Town of Parker Community Development Department
Development Review Division
Attention: **BrieAnna Simon**

Application Type: **Site Plan**
Status: **First Referral**
Application Name: B1 L2 Horseshoe Ridge – Multi Tenant Commercial Building
Case/AP#: **SP19-062**
Referral Received: June 19, 2019
Comments Due: July 18, 2019

Review date: **July 12, 2019**
Plan reviewer: **Randall L. Capra**, rcapra@parkeronline.org
Phone: 303.805.3169

TOWN OF PARKER - FIRE/LIFE SAFETY: **C REVIEWED FOR CODE COMPLIANCE w/COMMENTS**

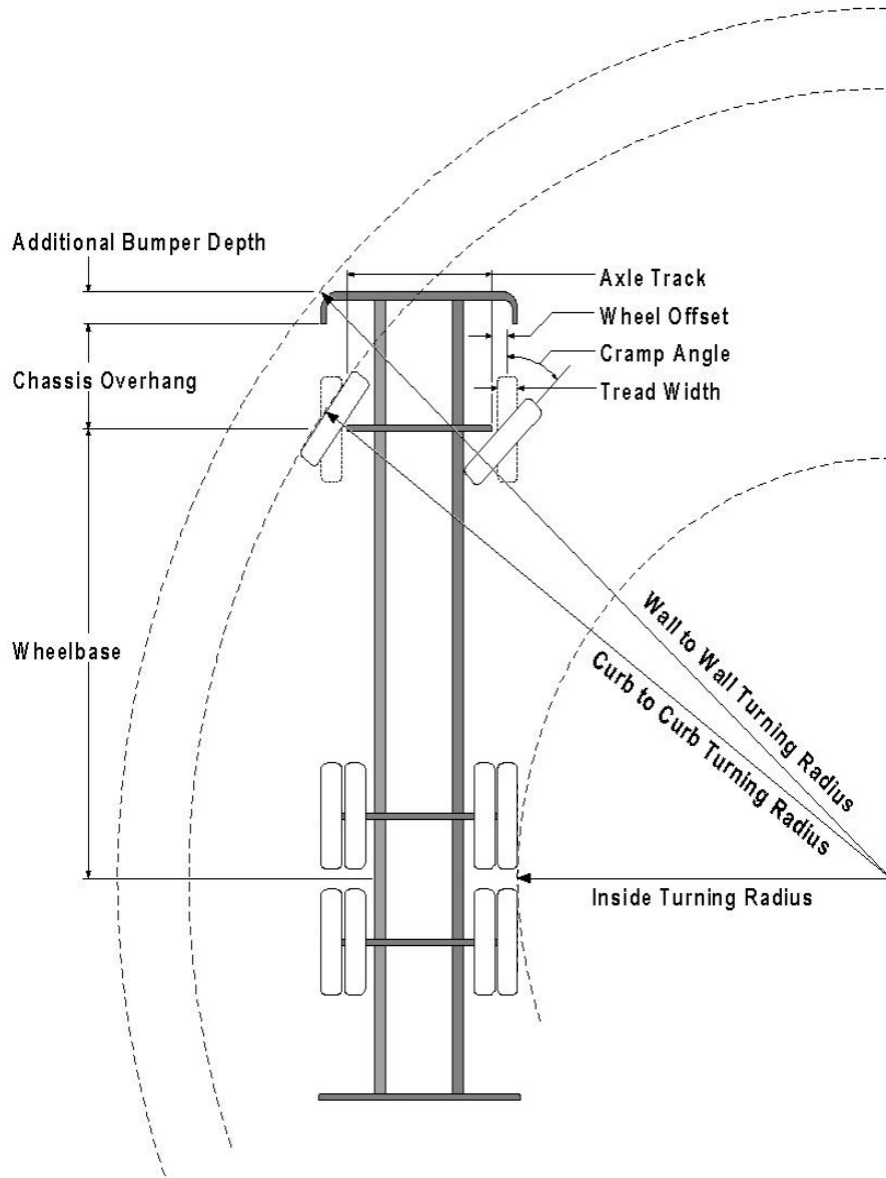
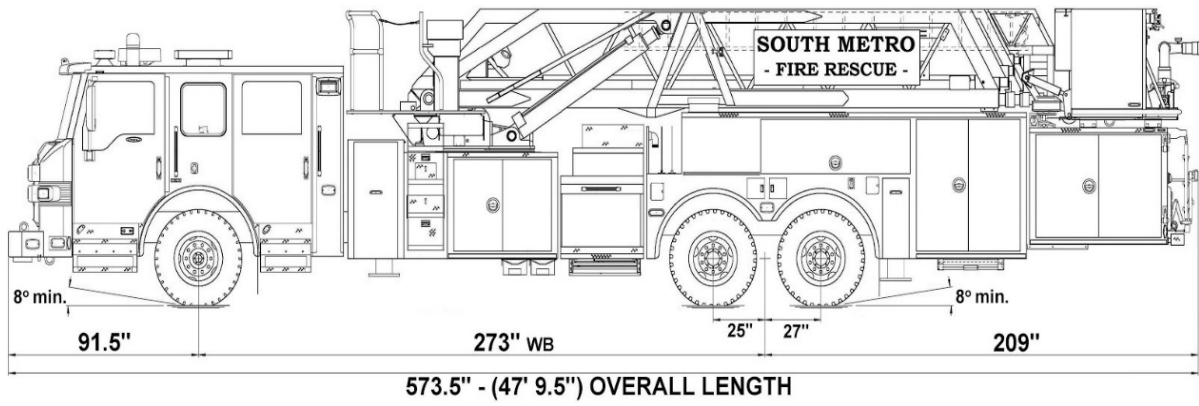
6. The applicant shall provide a fire hydrant, locating in the median, at the n/w corner of the building. Note – the fire hydrant and fire line are not allowed to share the same tap (see snapshot below): **Satisfied; applicant addressed with current submittal**
7. A better location for the riser room would be the n/w corner of the building with the access door to the riser room being located on the west side of the building. (see snapshot below): **Satisfied; applicant addressed with current submittal**
8. The applicant shall locate the FDC to the north side of the building... west end (see snapshot below): **Satisfied; applicant addressed with current submittal**
9. The applicant shall provide a man door into the fire sprinkler control valve room on the west side of the building (see snapshot below): **Satisfied; applicant addressed with current submittal**
